Surface water technical memorandum

TO	Pierre Miquel	COMPANY	Evolution Mining
FROM	Dayjil Buhle	OFFICE	Brisbane
PROJECT TITLE	Cowal Gold Operations Open Pit Continuation (OPC) Project		
SUBJECT	Surface Water technical input to Submissions Report		
DATE	24 January 2024	OUR REF	121155-18-M01 Rev1

Graph 1: Lake Cowal and Surrounds Level-Volume Graph

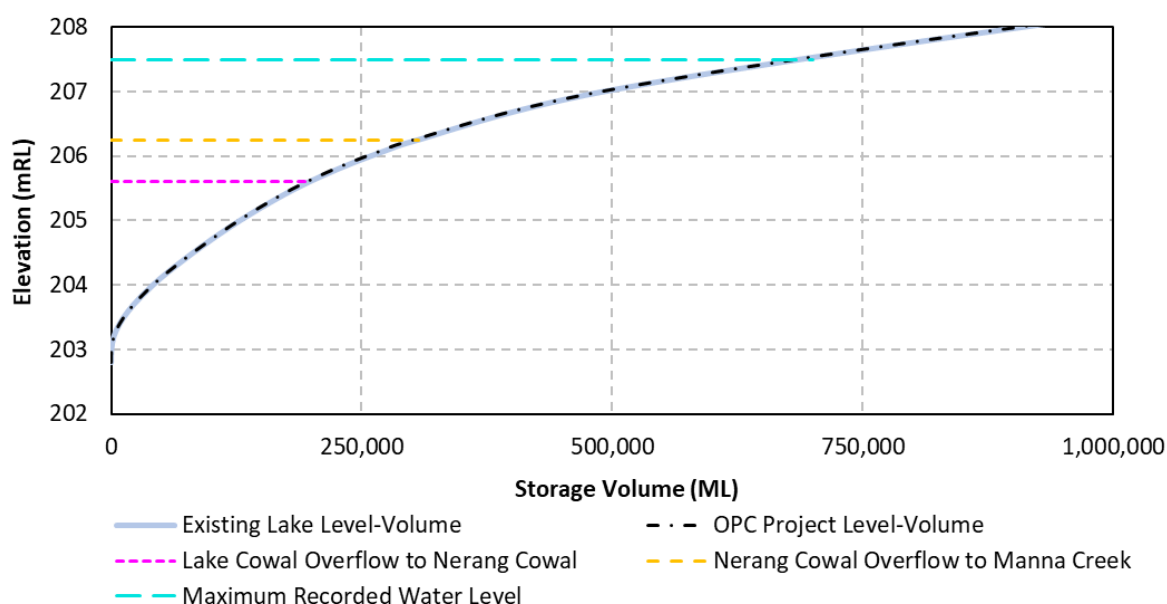
Community Submission (local landholder objecting to the Project): We feel like the calculation of a 1.7% volume increase is inaccurate as the EIS [Environmental Impact Statement] only states the water in Lake Cowal itself and does not include the total area of Lake Cowal, Nerang Cowal and their feeder creeks.

The flood modelling incorporated Lake Cowal and surrounds, including Nerang Cowal and feeder creeks. The reported change to the Lake Cowal volume (at each elevation) is relevant to all contiguous areas which would be affected by water at that elevation. This is demonstrated in **Map 1**, which presents the connected areas at three key elevations. The quoted 1.7% reduction (not an increase as stated in the submission) in lake storage volume, due to the proposed OPC Project, is the maximum reduction calculated across all elevations (with the 1.7% corresponding to 206.2 mRL). At higher elevations the level of impact reduces, for example, at 207.5 mRL there is a volume reduction of 0.6%.

Table 1 lists the area and volume reductions at some key water levels in Lake Cowal, Nerang Cowal and surrounds. **Graph 1** provides the level-volume relationship for Lake Cowal and surrounds, while **Map 1** shows the plan area extent of three of the tabulated key levels which were used to calculate the areas in **Table 1**.

Map 1: Key Levels in the Lake Cowal Level-Volume Graph and Landholders

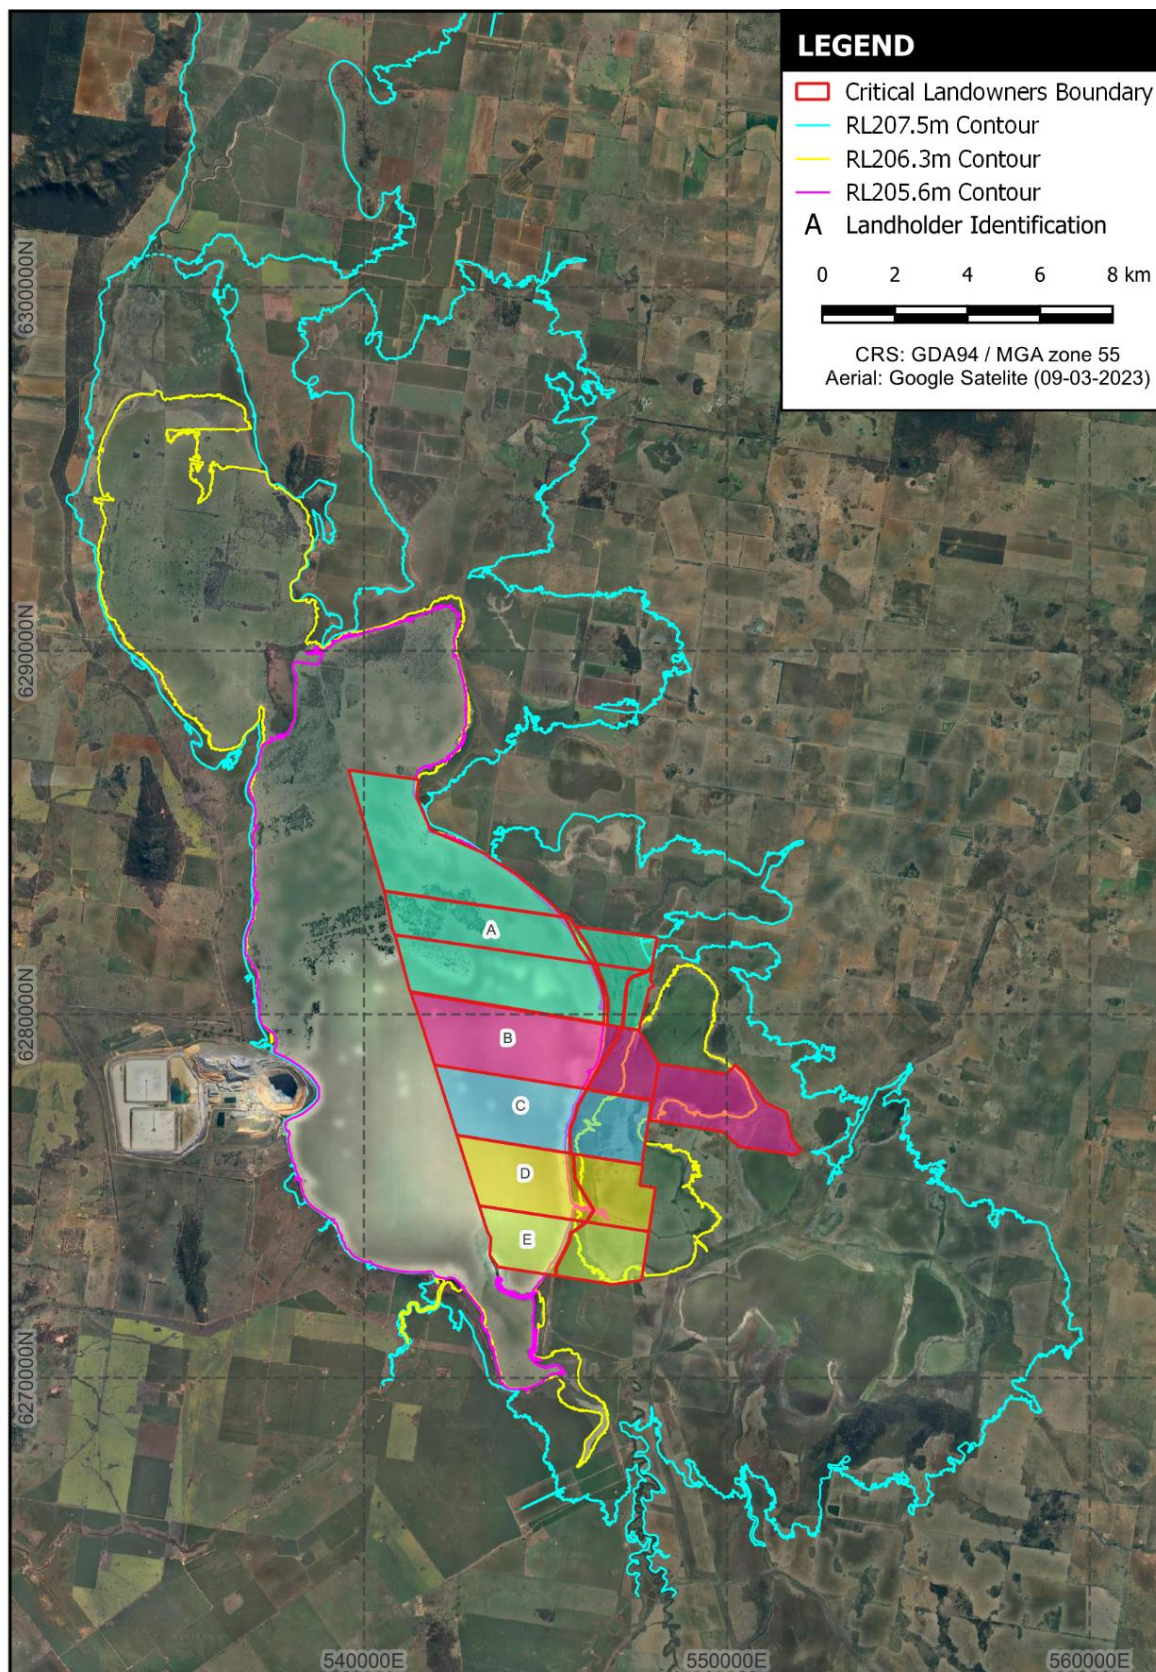
Community Submission (local landholder commenting on the Project): We are concerned with the impacts on our farming land within the lakebed from the increase in the mine bund. The increased land area that will be encompassed and the amount of water that will be displaced as a result.

To assess the likely impact to inundation days due to the simulated increase in lake water levels as a result of the OPC Project, the minimum level of landholders properties were identified (refer **Map 1** and **Table 3**). The Lake Cowal water balance model (refer Section 6.5.1 of the SWA) was used to estimate the change in the number of days that the modelled water levels would be above the minimum level for each landholder's properties for both the existing situation and with the proposed OPC Project.

Graph 2: Proposed Lake Protection Bund Level-Volume Graph

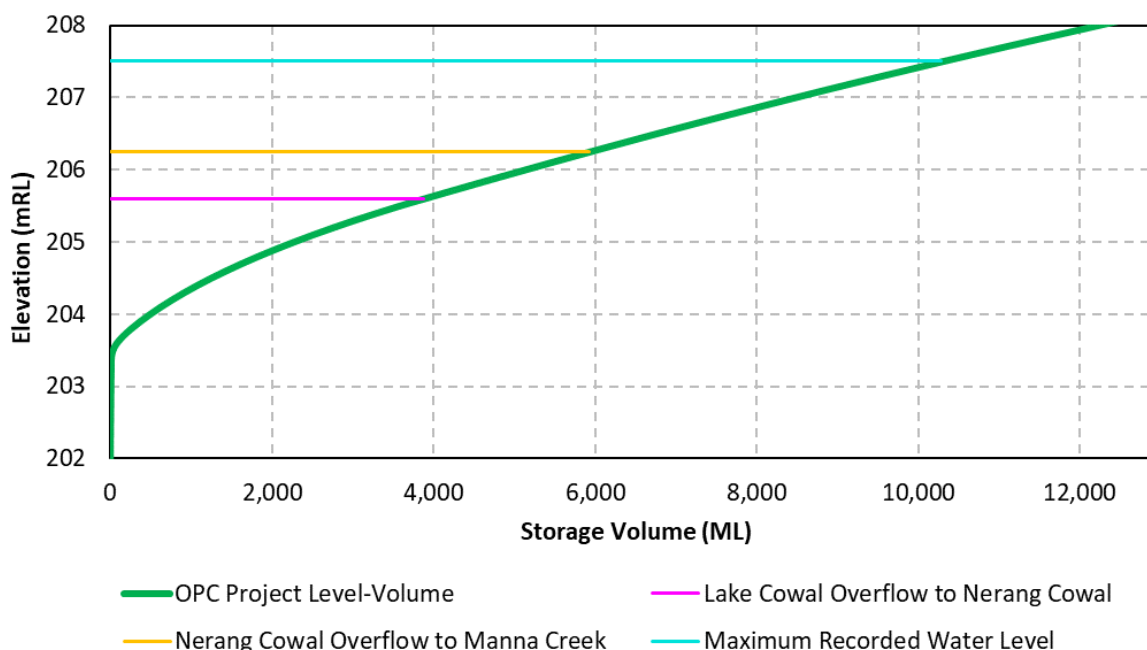
Lachlan Valley Water: Some landowners have also expressed concern that the Lake Protection Bund will displace about 4,000 ML of water in Lake Cowal, and effectively increase the lake level by around 15mm. While this may not be considered a significant increase, when combined with heavy rainfall and severe flooding as experienced in the Lachlan in 2022, there can be an impact on neighbouring properties and additional flooding that may not previously have occurred. Farmers in the Lake Cowal region are concerned about the potential impacts on their properties and seek further discussion with Evolution Mining about how this could be managed.

The level-volume graph for the area behind (upslope of) the proposed expanded LPB is provided below in **Graph 2**. The LPB is estimated to displace approximately 3,900 ML at 205.6 mRL, the estimated level at which Lake Cowal overflows to Nerang Cowal.
